Report for Selwyn District Council

Review of Mansergh Graham Landscape Architects Glint and Glare Assessment of Darfield Agrivoltaic Development by NZ Clean Energy Ltd

**Prepared by: Rudi Van der Velden
Date: 19 November 2024
Velden Aviation Consulting Ltd**

Figure 1.3 Applicants drawing of proposed solar panel layout

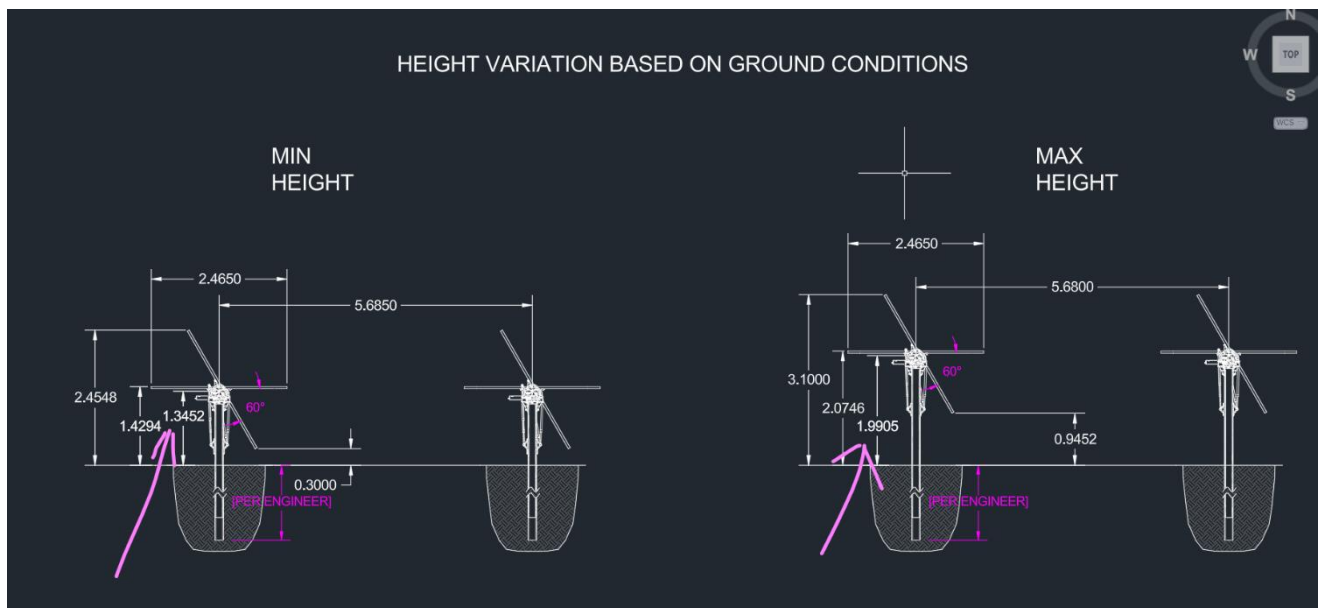
3. Rotation Axis Height above aground	1.4m	NOTE: There were no diagrams of the actual solar panel layout on the rotation axis in the Mansergh Graham glare assessment Further feedback from Applicant indicates that height may vary from 1.4m (as used by Mansergh Graham Assessment) and 2.07m as indicated in Figure 1.3 provided by Applicant.

4. Max tilt angle	60 °	Noted in assessment
5. Max Height above ground.	2.8m	Ref: AEE Final, 6 September 2024, 3.2.1 The Solar array. NOTE: There was no consideration of this in the Mansergh Graham glare assessment. Follow up correspondence with applicant indicated that minumum height would be 2.45m and maximum height 3.1m as per Figure 1.3.

The maximum height however is based on diagram provided below by the Applicant. This indicates a maximum height of 3.1m and is used to allow a more conservative consideration as it applies to minimum height mitigation screening such as possibly being proposed for new landscape planting.

1. That given the maximum height of the proposed solar arrays are potentially 3.1m based on the drawings provided by the applicant NZ Clean Energy Ltd, that any proposed landscape mitigation planting be at least 4m high to ensure adequate screening from any potential view by observer points.

Figure 4.1 Predicted Glare Occurrence and Daily duration for 1352 Homebush Road

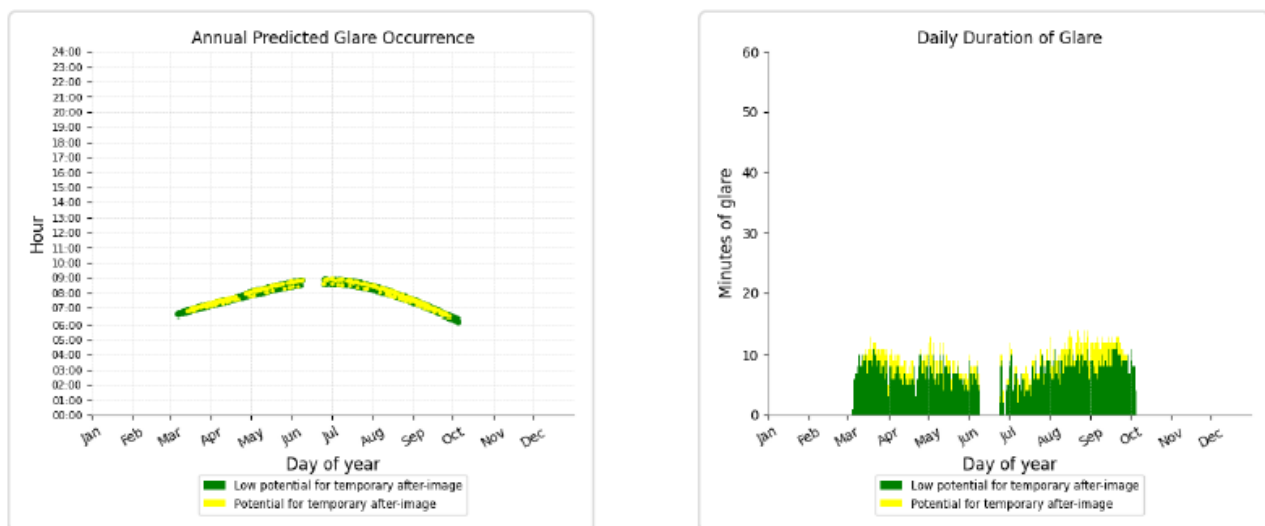
With Dwelling at 1352 Homebush Road (OP1) with the largest predicted amount of glare at 25 hours green glare and 27.4 hours per annum yellow glare, VACL concurs with the MGLA assessment that the existing vegetation surrounding this dwelling should mostly mitigate this to minor and even less than minor.

As noted in the ocular hazard definitions in section of 1.4, green glare is expected to have low impact compared to yellow glare which should ideally be mitigated as far as practicable where glare levels exceed 10 hours per annum for dwellings as per the Australian guidelines.

It should be noted, the simulations of existing vegetation obstruction to mitigate glare provided by both MGLA and VACL should theoretically have completely screened all potential glare based on the geometry angles between the Observation Point 1 (Dwelling at 1352 Homebush Rd), the existing vegetation and the solar array location. The mechanism for this is illustrated in **Appendix E** and the reviewer believes this to be an anomalous result as there should be complete screening of the array for this dwelling based on its existing surrounding vegetation. (The reviewer has raised this with the software developers and at time of writing of this report has not had a reply from them.)

Photo 4.2-2 Gunns Road location and intersection with State Highway 73

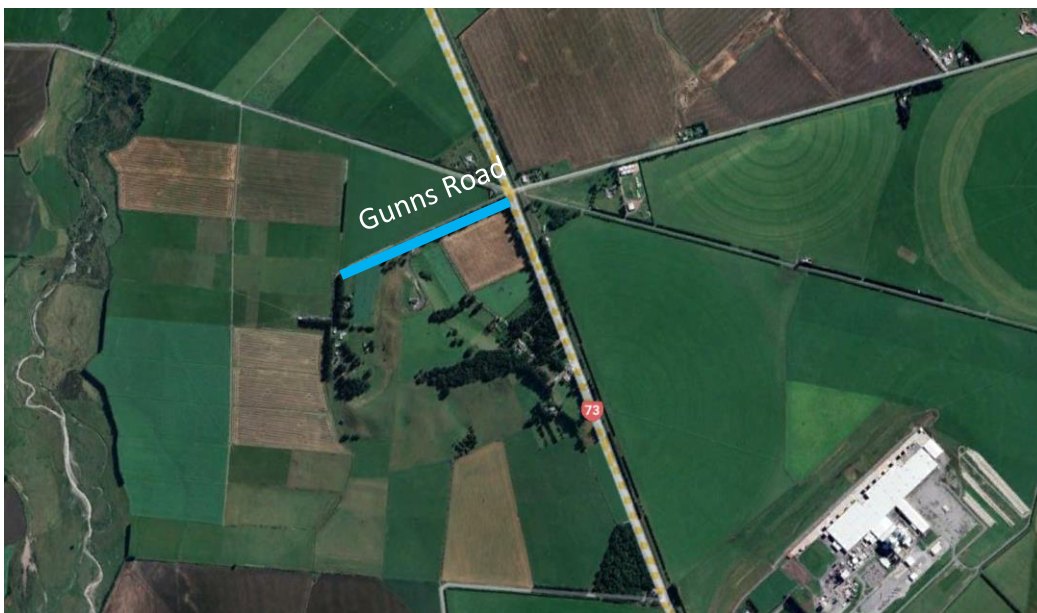
Note 2- Gunns Road (see below) was included in the assessment by VACL given it meets a major intersection that may potentially encounter glare from the Darfield Solar Farm.

Rationale for inclusion of Gunns Road is due to major intersection with State Highway 73

Photo 4.2-3a and b. View from Gunns Road looking at Viewpoint 1 (VP1)

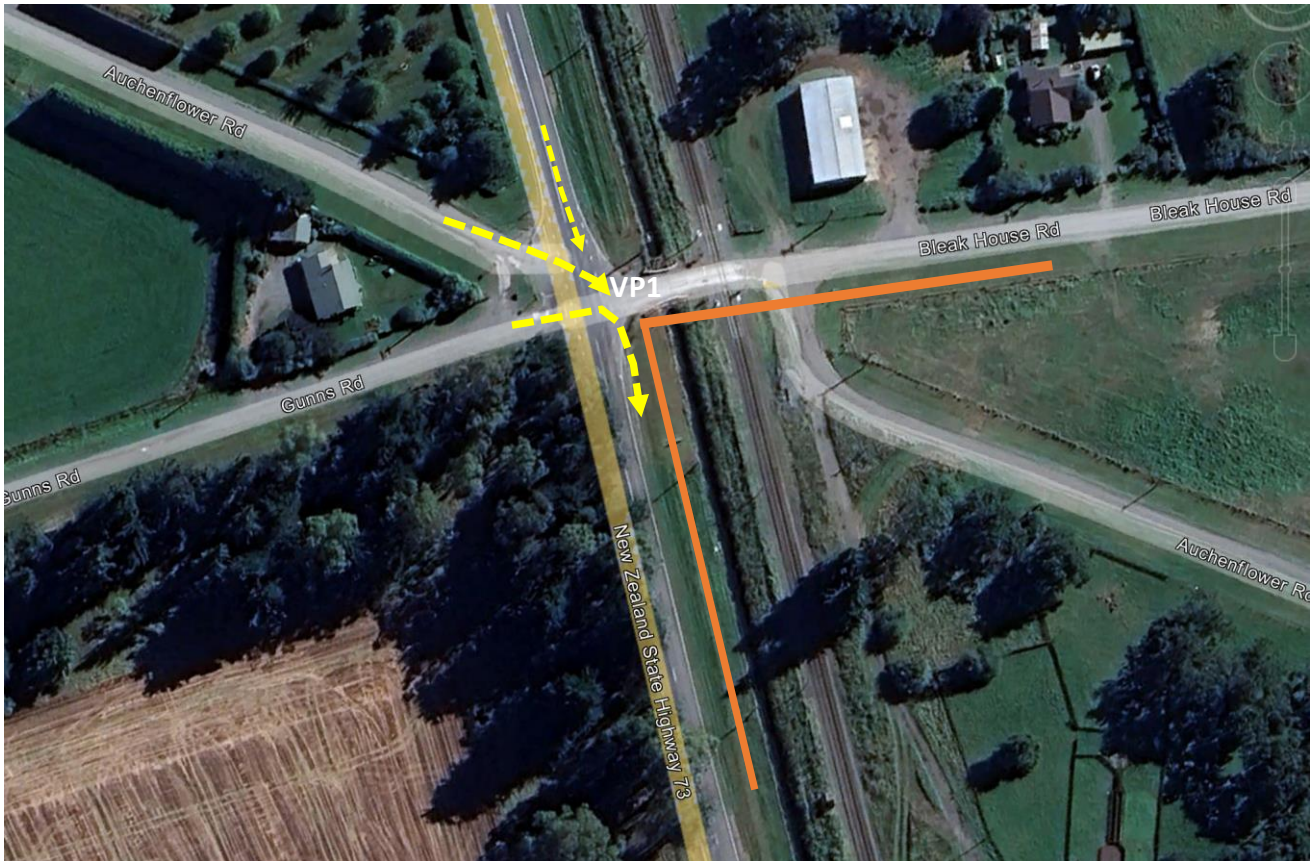
While not included in the MGLA report, the peer reviewer from VACL considered it important to include roads at major intersections where there is potential of glare from Solar Farm developments due to potential safety issues encountered at major intersections, especially in New Zealand rural roads.

In this instance, based on viewpoint 1, the results outcome of no potential predicted glare at this point is likely due to the existing vegetation and building structures in the background as seen from this point.

Figure 4.2- 4. Recommended Obstruction landscape planting along Statehighway 73 at Homebush Road Intersection.

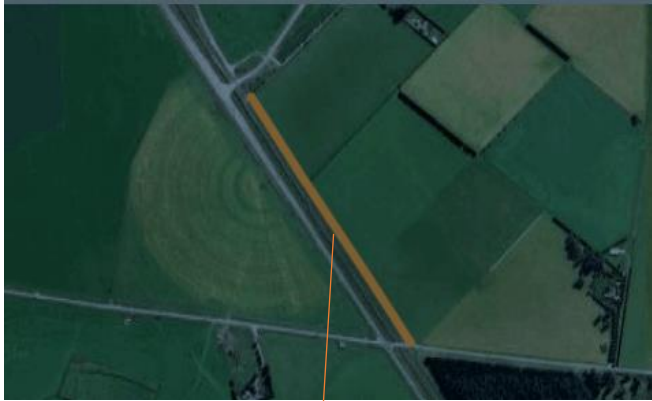
VACL has considered added vegetation planting along the boundary of West Coast Rd (Statehighway 73) and Homebush road east of the intersection as indicated in Figure 4.4 below.

This also supports the comment made above from the Landscape and Visual Assessment Report. The minimum planting proposed is 4m and based on this modelling the glare, the VACL result in table 4.2 indicate that this eliminates any potential glare for Boultons Road, Clintons Road and Homebush Road East and West of Railway.

This also provides an important safety measure against any glare that may be experienced at this intersection both for road as well as rail.

Figure 4.2-5 shows there is currently no existing vegetation that would obstruct the view of the solar arrays when approaching this intersection indicating a potential safety issue of encountering glare. As MGLA results show there are 602 mins of yellow glare for large vehicles traveling along Homebush road east of railway and 307 mins of yellow glare for large vehicles travelling along Homebush road west towards the intersection.

The schematic shows obstruction screens in the peer reviewers simulation of 4m high landscape plantings that should potentially obscure large and small vehicle driver view of the proposed solar array and hence any potential glare from it. The VACL results from table 4.2 indicate that there should be no predicted glare once incorporated. This would support the applicants Landscape and Visual Assessment report indicating its intention to consider such landscape planting.

2. That landscape planting along Auchenflower Road and towards and around the Homebush Road and Statehighway 73 intersection be at least 4m high to ensure it is above any potential view of the solar arrays and be sufficiently dense enough to eliminate potential glare from the solar array.

Auchenflower Road

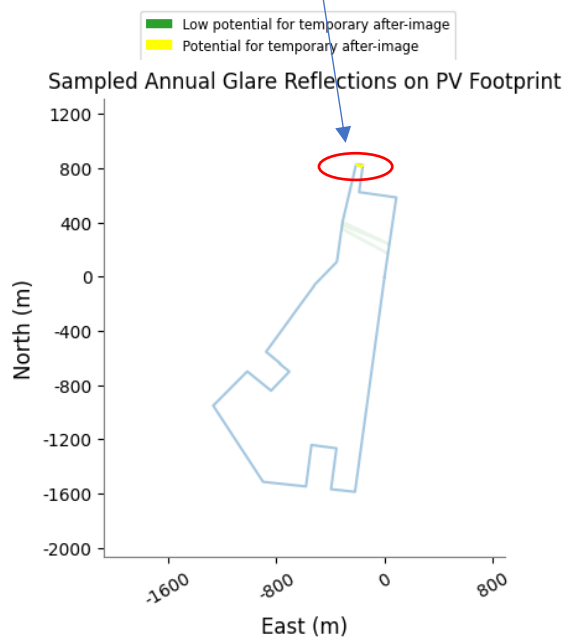
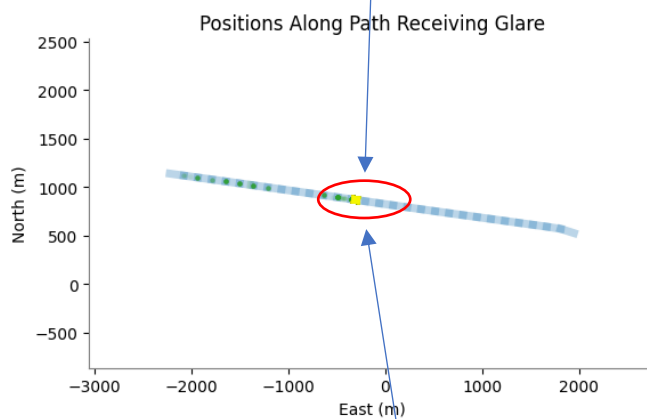
Auchenflower road indicates there is potential green and yellow glare of 476 mins/year and 222 mins/year respectively. The photo location correlation with the simulation glare reflection on the PV footprint shows where glare can be expected. It also shows where there is no existing vegetation along this point as shown in photo below and where the yellow line along the road indicates where yellow glare may be seen.

A 4m high obstruction simulating a landscape planting along this point has been analysed with resultant potential yellow glare being mitigated and potential green glare being reduced from 476mins to 268mins per year.

With green glare unlikely to cause any significant issue given the dynamic nature of the moving vehicle and minimum glare factor associated with green level glare, the overall impact of potential glare on road users with existing vegetation and that of planned landscape planting should be minimized to minor or less than minor.

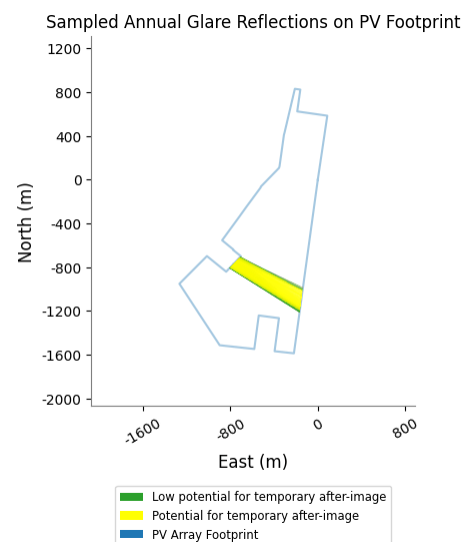
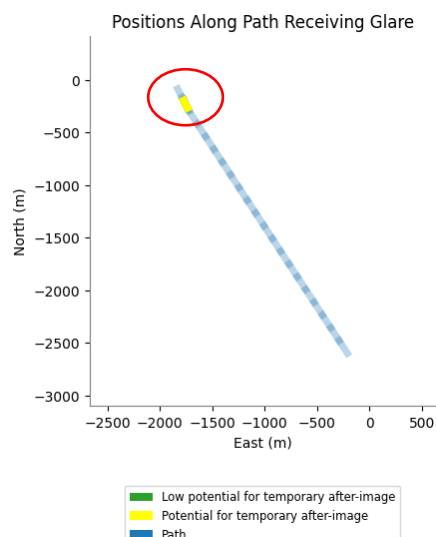
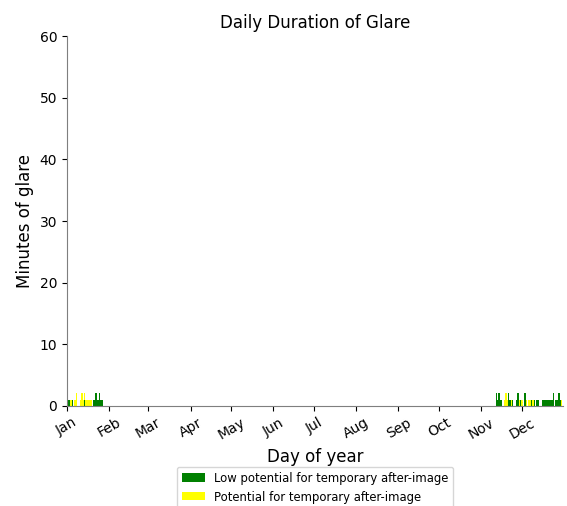
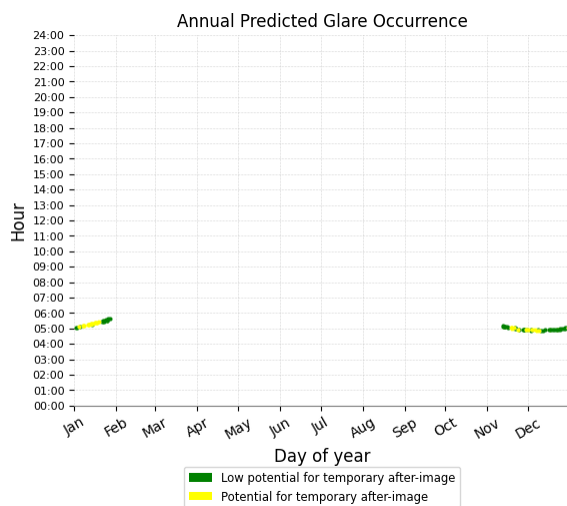
For the Main trunk line, a minimal amount of glare can be expected with less than 3 mins per day of mostly green glare. This is likely to happen for trains travelling east in early hours of the morning as indicated from the plots below.

With regard to the location highlighted in red below and its correlation point also highlighted in red on plot showing positions along path receiving glare, it is expected that train drivers are not likely to encounter any potential glare as indicated in the above plots above which already show minimal glare. This is based on likelihood that existing vegetation as well as buildings around Fonterra Plant (which have not been included in obstruction simulation) are likely to obscure the already minimal view of the Darfield solar array and hence any potential glare from it.

Photo 4.3 also shows significant hedgerow at least 4m -5m high adjacent to the rail track that is likely to obscure most of the drivers view towards the PV array.

Figure 4.3 -1. Fonterra Railway Siding and site obstructions likely to mitigate potential glare from PV Array

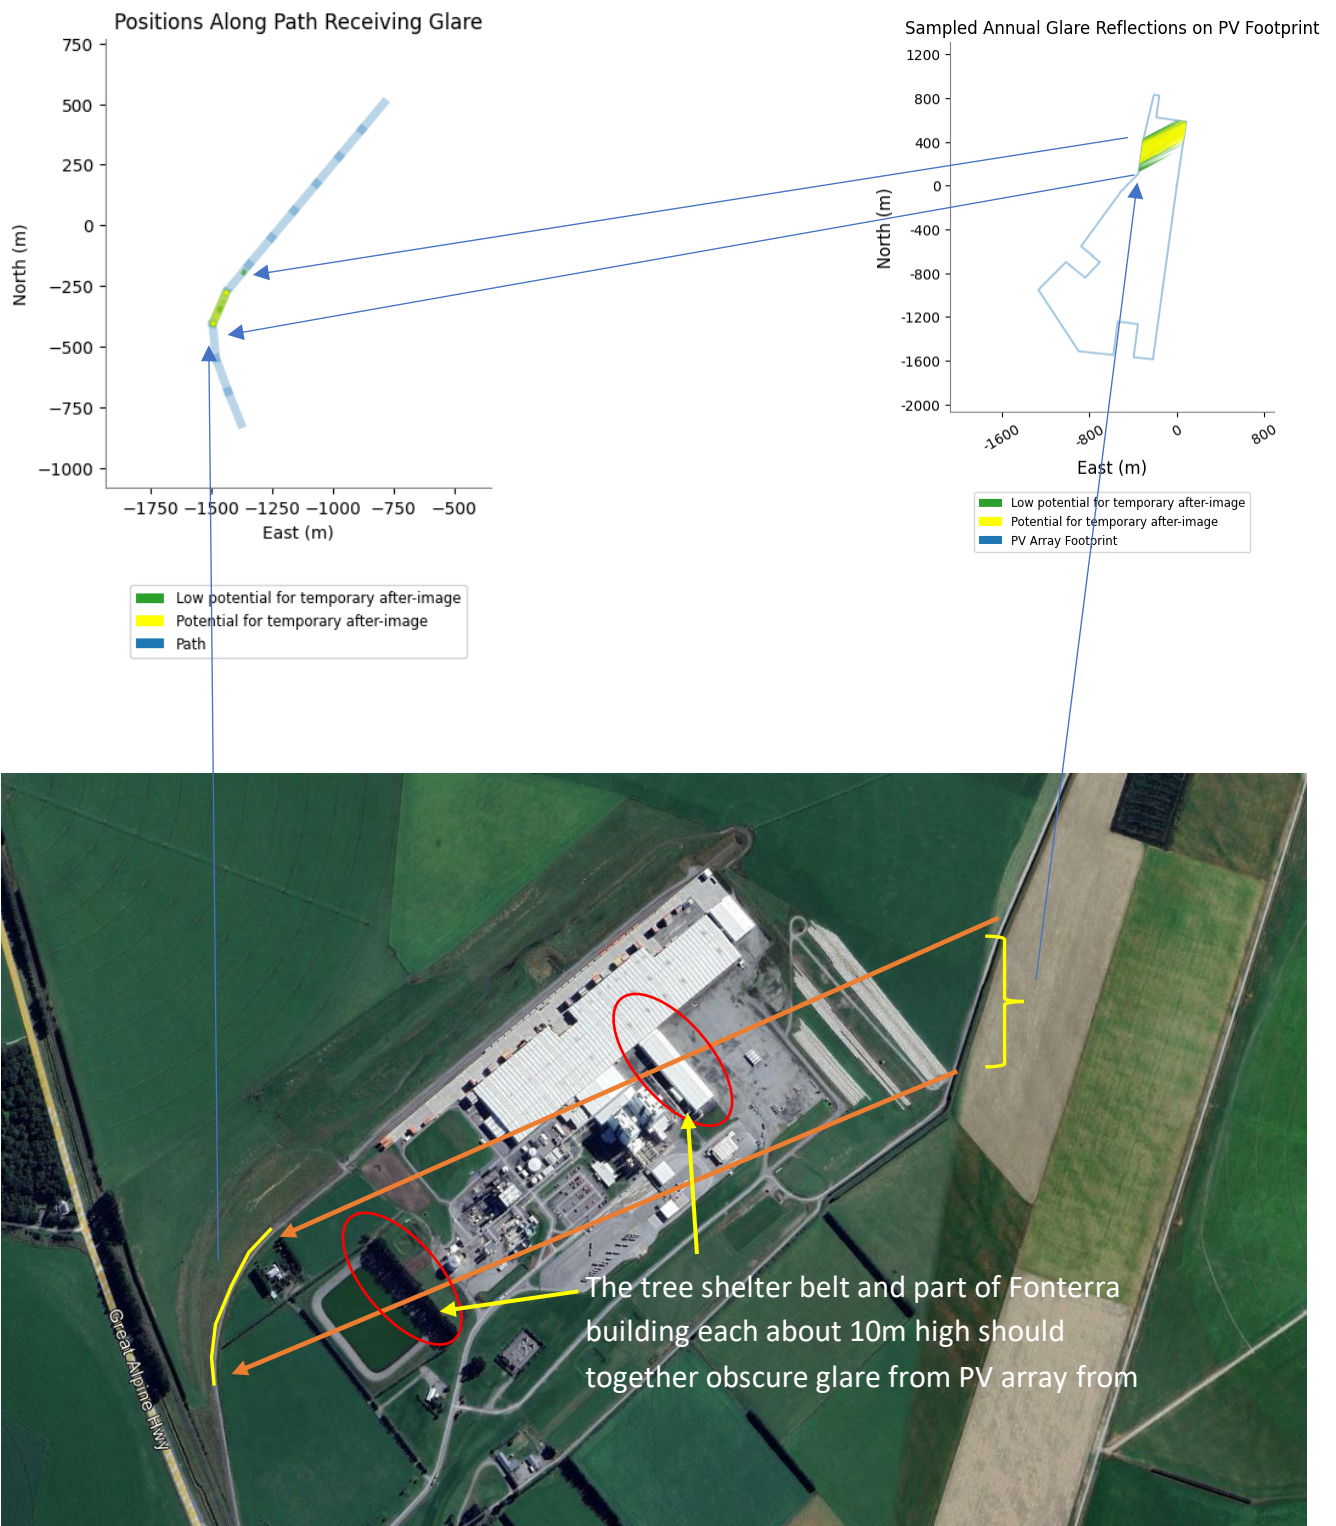
For the Fonterra railway siding, potential glare is predicted to be experienced very briefly in the morning only and in the direction as the train travels towards the Fonterra plant.

It is likely that parts of the tree shelter belt and Fonterra building (see plots and figure 4.3 below) will also mostly mitigate an already minimal glare 58mins/year green glare and 8 mins/per year yellow glare which can be considered minor to less than minor impact in terms of predicted glare impact to the train driver due to short duration from the moving train.

Figure 4.3-2 Annual Predicted glare and Daily duration for Railway Siding

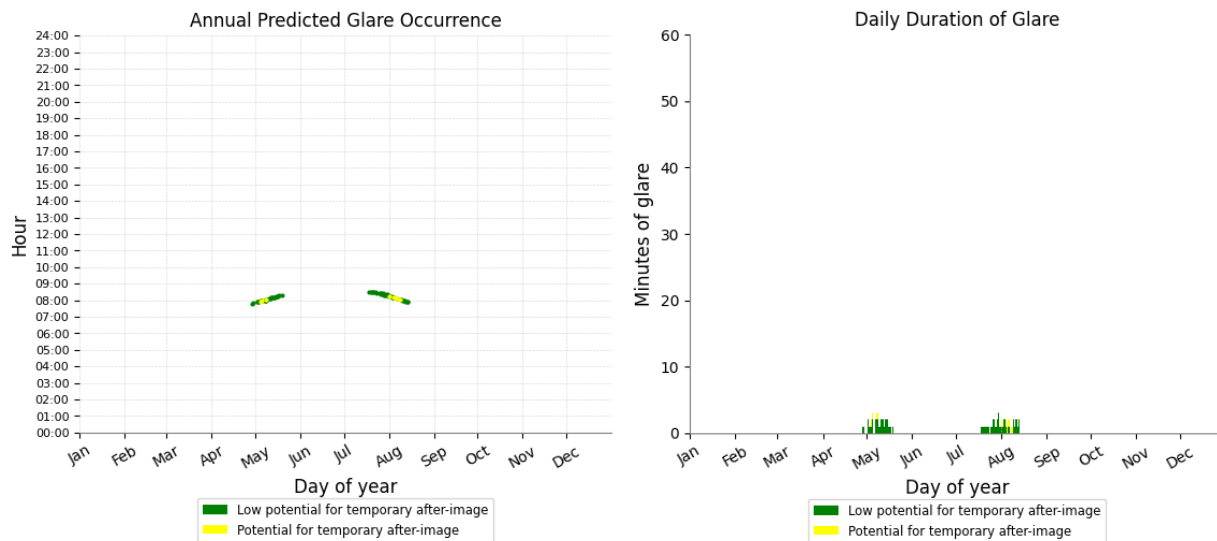
The annual predicted glare occurrence and daily duration plots indicate minimal predicted glare which is mostly low level green glare and as such should only present minor impact. With the likelihood of further obstruction of the view to the PV array from the tree shelterbelt and Fonterra building structure as circled in red in the above photos, it is expected that any glare should be less than minor if not completely mitigated by these structures.

APPENDIX E : Obstruction Observer Point 1 Anomalous Result

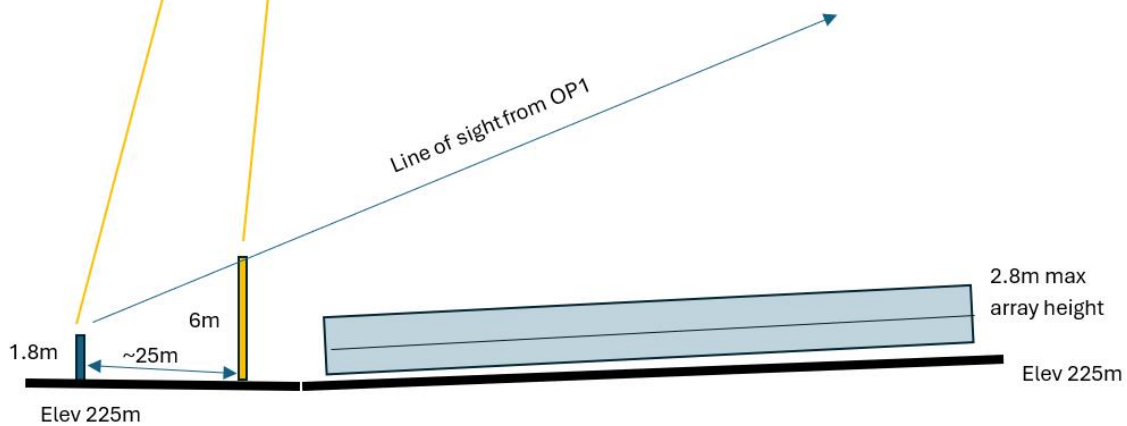
OP 1 Green glare 25 hours per annum and yellow glare 27.4 hours per annum

Existing Vegetation obstruction should obscure any view of solar array from observer point 1 and hence any glare.
